Contract No. YL/2023/03
Hung Shui Kiu/Ha Tsuen New Development Area Second Phase Development – Contract 3 – Site Formation and Engineering Infrastructure Works

Environmental Permit No. EP-530/2017
Submission of Supplementary Contamination Assessment Plan (Batch 4)

Supplementary Contamination Assessment Plan (Batch 4)

Figure 2 Locations of Potentially Contaminated Sites

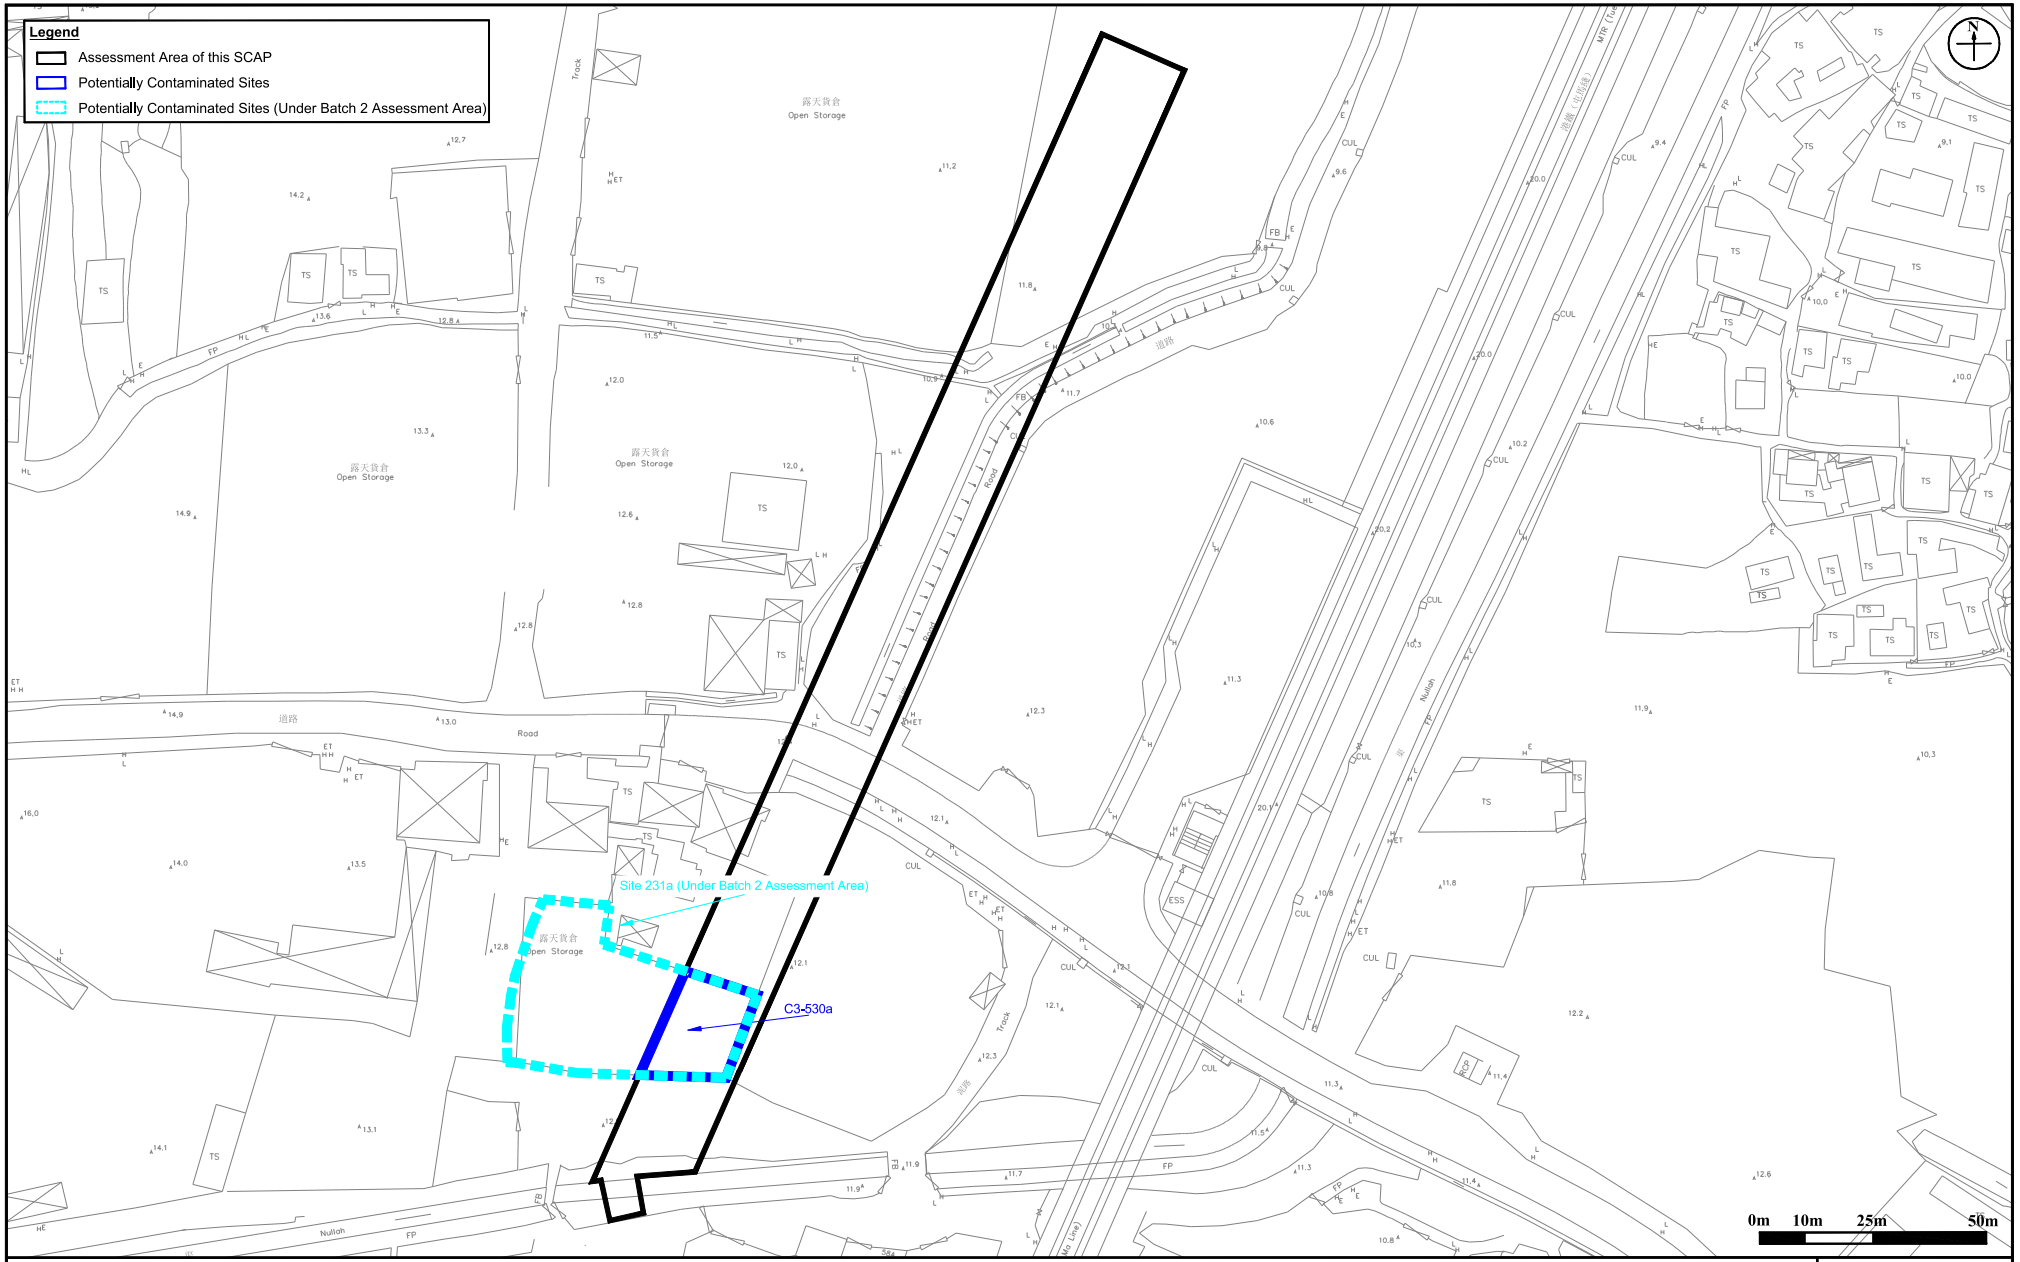
Comments	Responses
ET's Comments dated 15 Oct 2025	
1. Figure 2 – Please clarify the areas other than potentially contaminated sites and areas with no potentially contaminating activities identified.	Please be clarified that "potentially contaminated sites" denotes the sites identified with potential contamination issues in the Approved CAP and/or Final CAP and this SCAP. For the "areas with no potentially contaminating activities identified", it denotes the areas identified with potential contamination issues in the Approved CAP and/or Final CAP but not in this SCAP. For the areas not defined as the areas mentioned above, they are not identified with potential contaminated issues in the Approved CAP, Final CAP and this SCAP. Details of the site ID and its potential contamination activities have been presented in Appendix F. Remark is added in Figure 2.

Remark:
(1) "potentially contaminated sites" denotes the sites identified with potential contamination issues in the Approved CAP and/or Final CAP and this SCAP. For the "areas with no potentially contaminating activities identified", it denotes the areas identified with potential contamination issues in the Approved CAP and/or Final CAP but not in this SCAP. For the areas not defined as the areas mentioned above, they are not identified with potential contaminated issues in the Approved CAP, Final CAP and this SCAP. Details of the site ID and its potential contamination activities have been presented in Appendix F.

Figure: 3	RAMBOLL
Title: Proposed Sampling Locations	Drawn by: SC Checked by: ZC
Project: Contract No. YL/2023/03 Hung Shui Kiu / Ha Tsuen New Development Area Second Phase Development - Contract 3 - Site Formation and Engineering Infrastructure Works	Rev.: 4.0 Date: Dec 2025

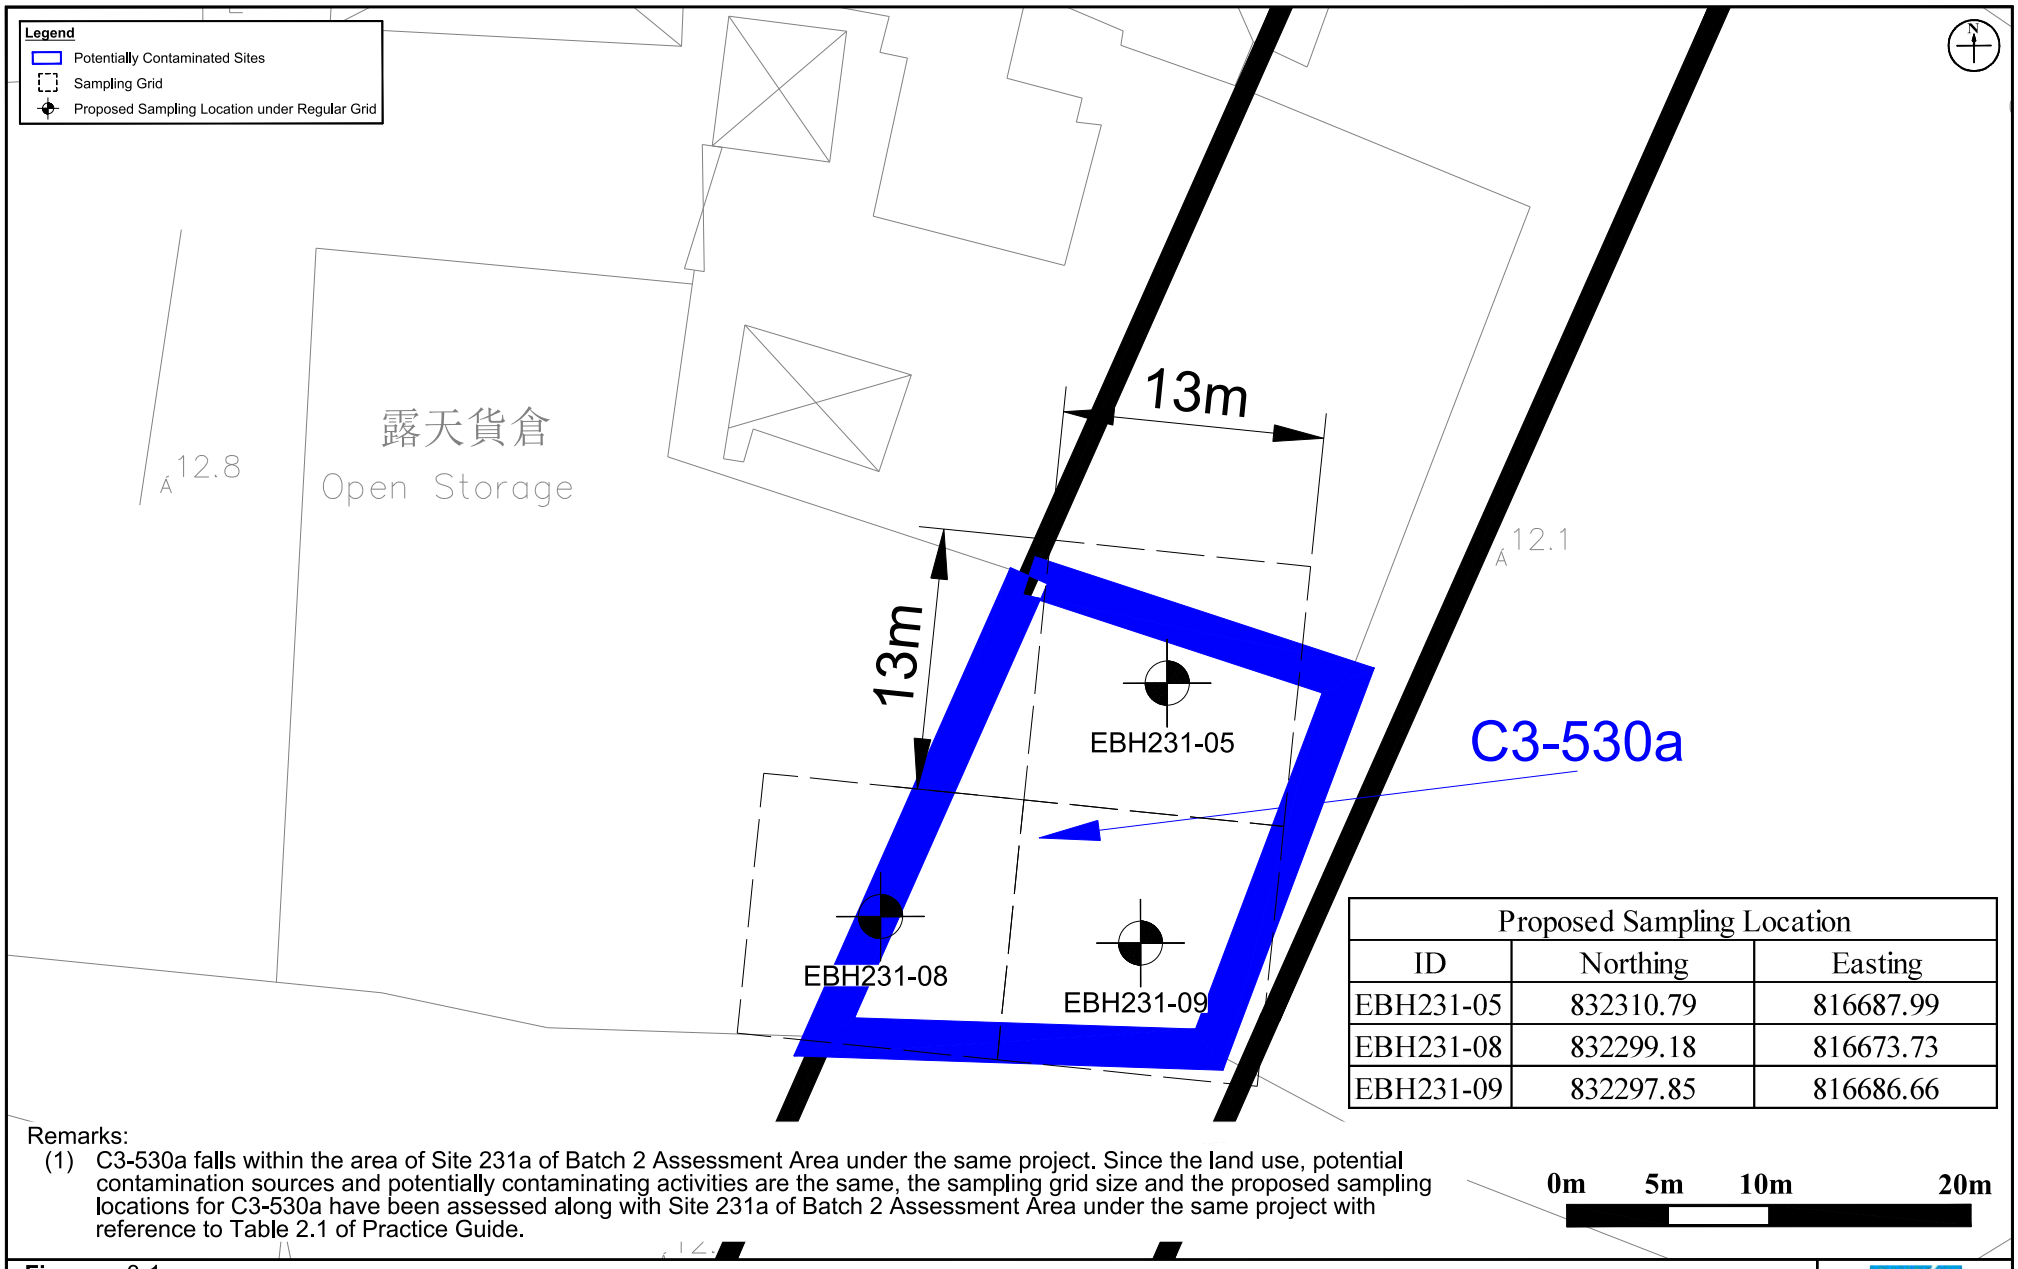
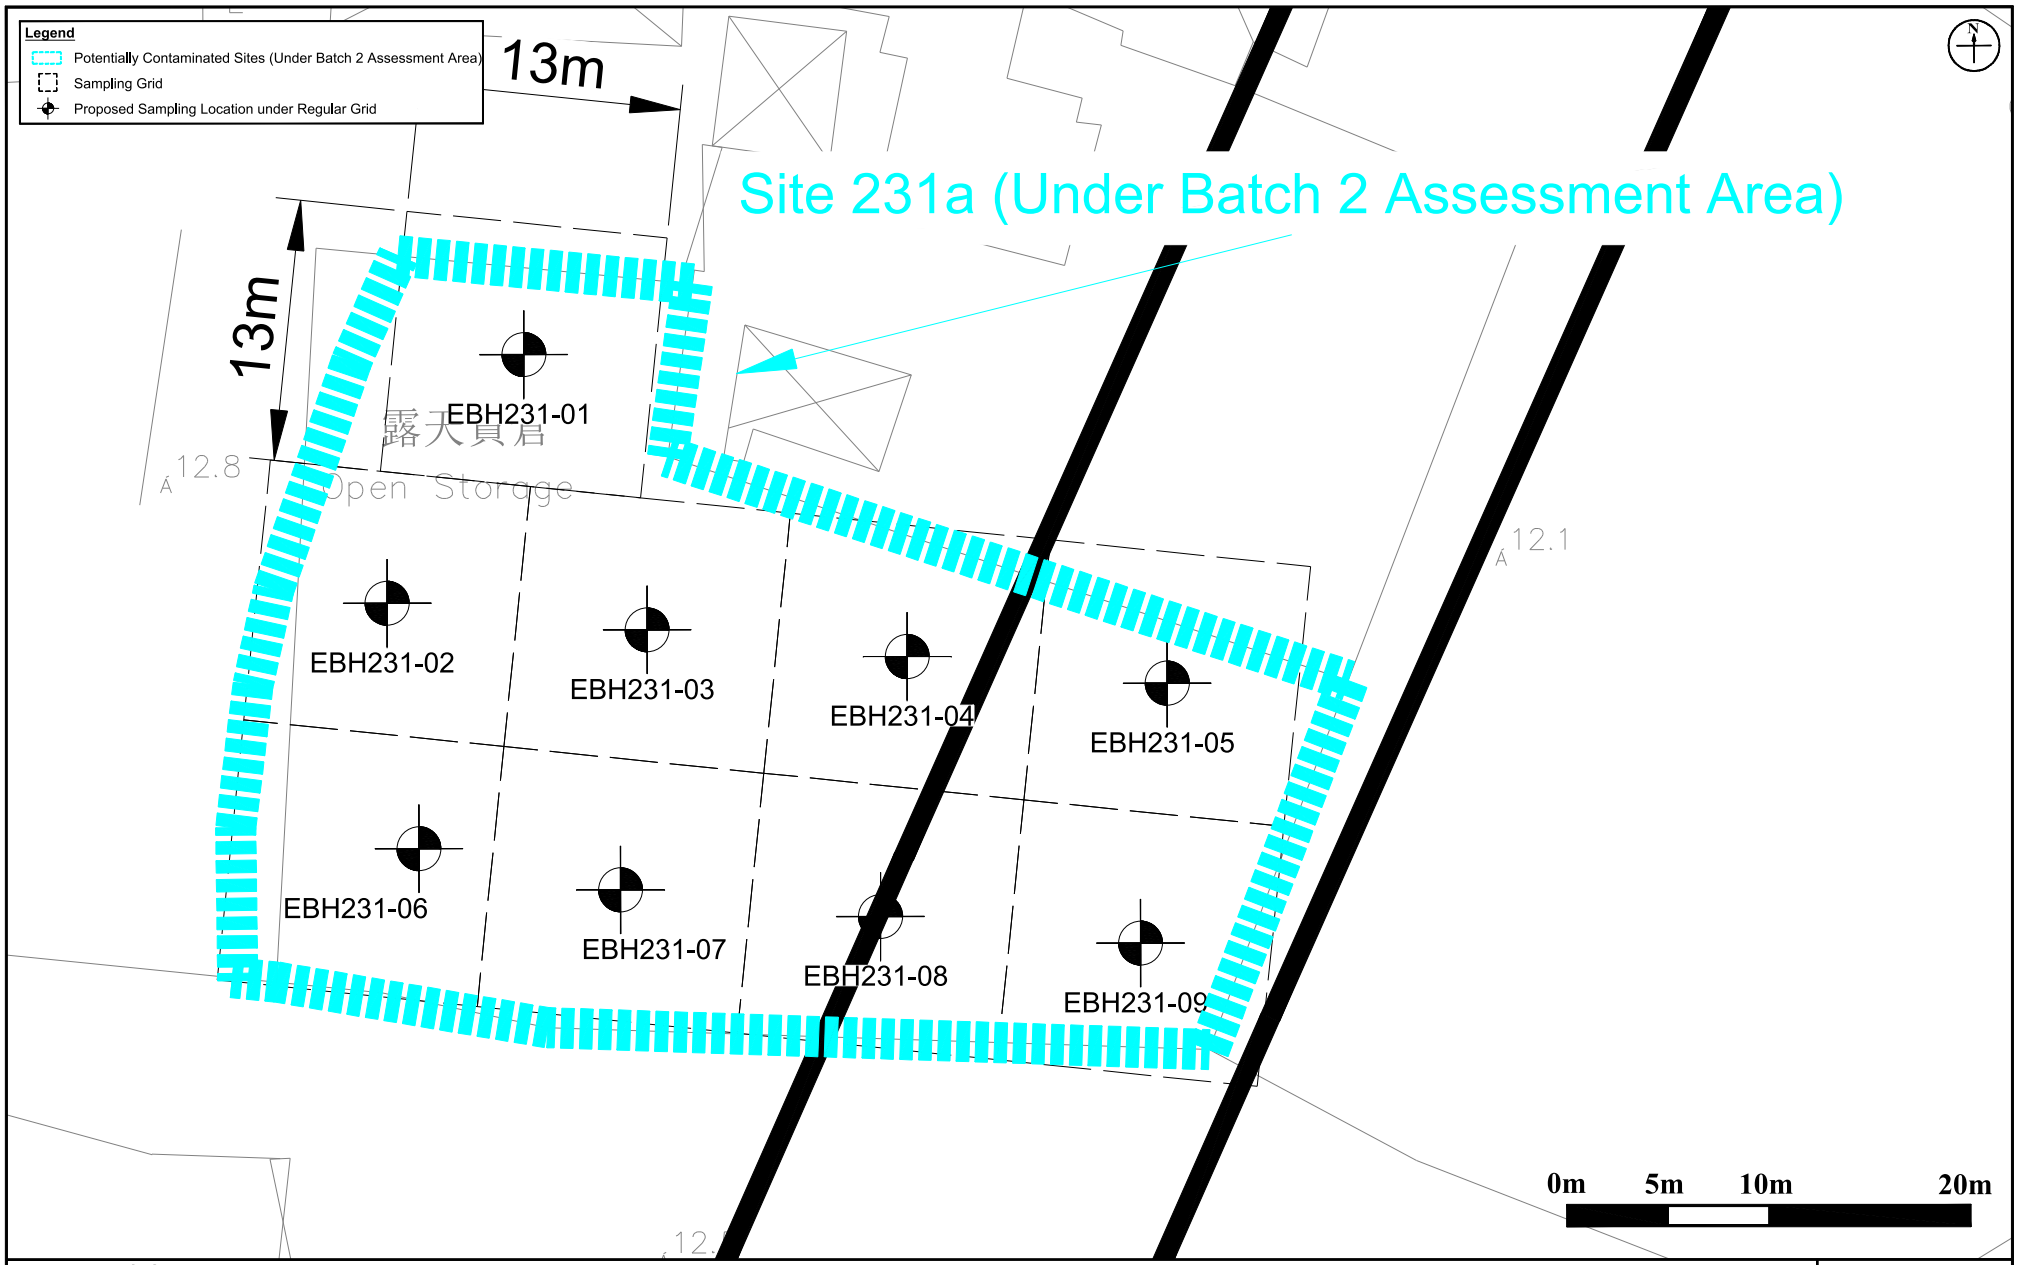
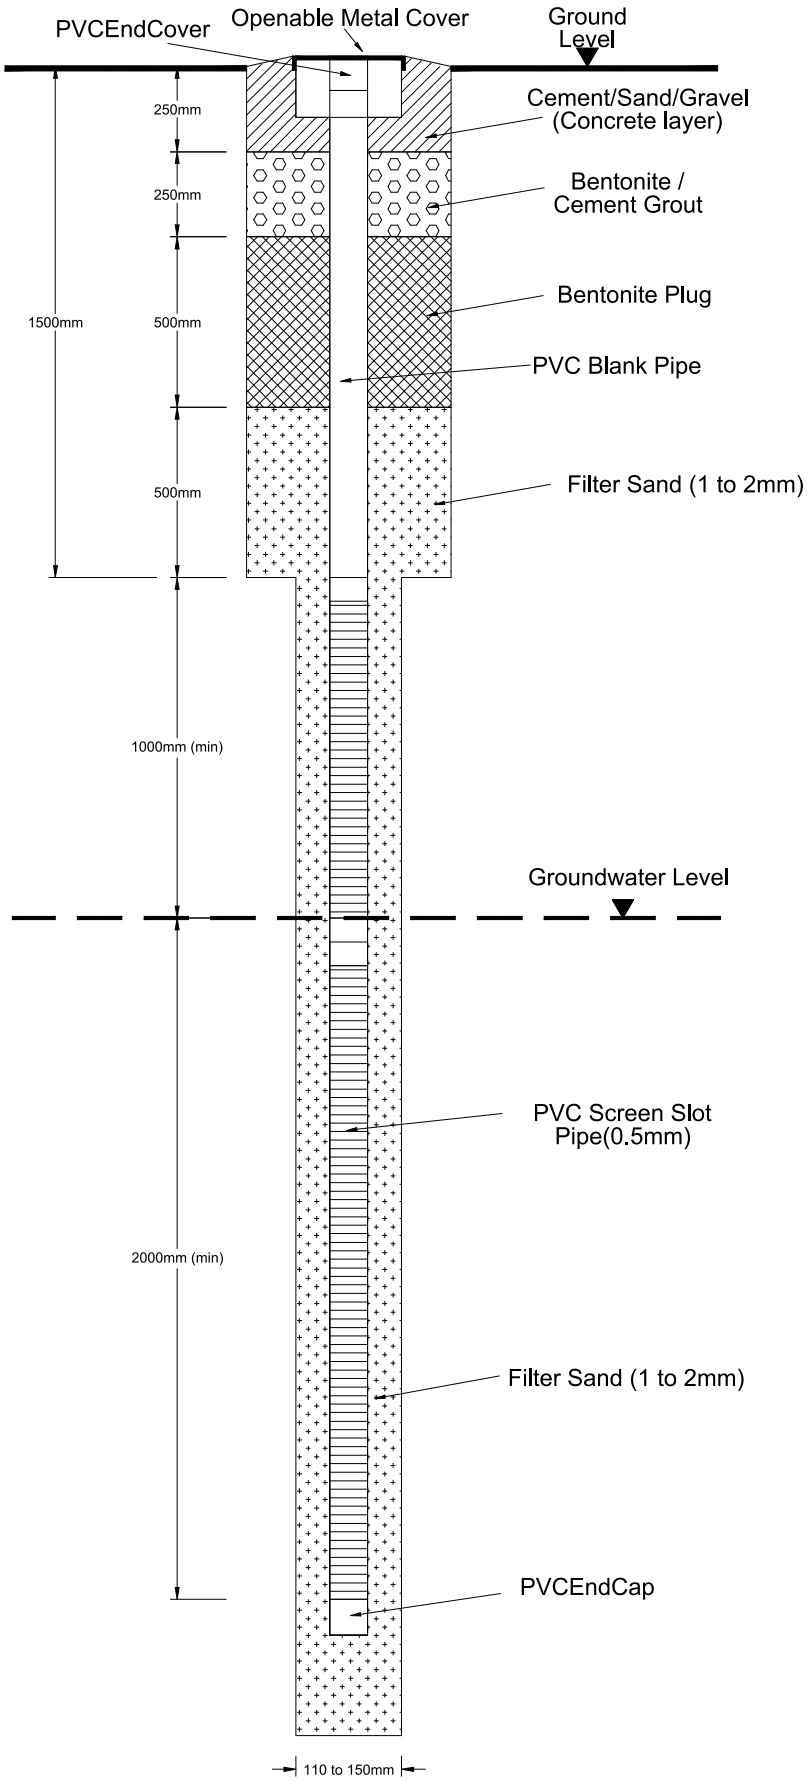
2. Figure 3 – Please provide coordinates for the sampling locations.	Coordinates of proposed sampling locations have been added in Figure 3.

1. Rtc (8) 8.1.4 The conclusion of COCs is incorrect. Please rectify.	Noted and S8.1.4 has been updated.
2. Rtc (5) & (6) Table 5.1 & Appendix F Please illustrate the relative locations of C3-530a and 231a, indicating the batch number and sampling arrangement. Please clarify whether C3-530a and 231a are associated with the same potential contamination sources. If not, they should be considered and assessed separately.	The relative locations of C3-530a and 231a are shown in Figure 3. Please be clarified that C3-530a and 231a are associated with the same potential contamination sources, therefore, these two sites should be considered and assessed together. Table 5.1 and Appendix F have been revised accordingly.

Remark:
(1) C3-530a falls within the area of Site 231a of Batch 2 Assessment Area under the same project. The relative locations of C3-530a and Site 231a are shown in **Figure 3.** Since the land use, potential contamination sources and potentially contaminating activities are the same, the sampling grid size and the proposed sampling locations for C3-530a have been assessed along with Site 231a of Batch 2 Assessment Area under the same project with reference to Table 2.1 of Practice Guide.

Proposed Sampling Location		
ID	Northing	Easting
EBH231-05	832310.79	816687.99
EBH231-08	832299.18	816673.73
EBH231-09	832297.85	816686.66
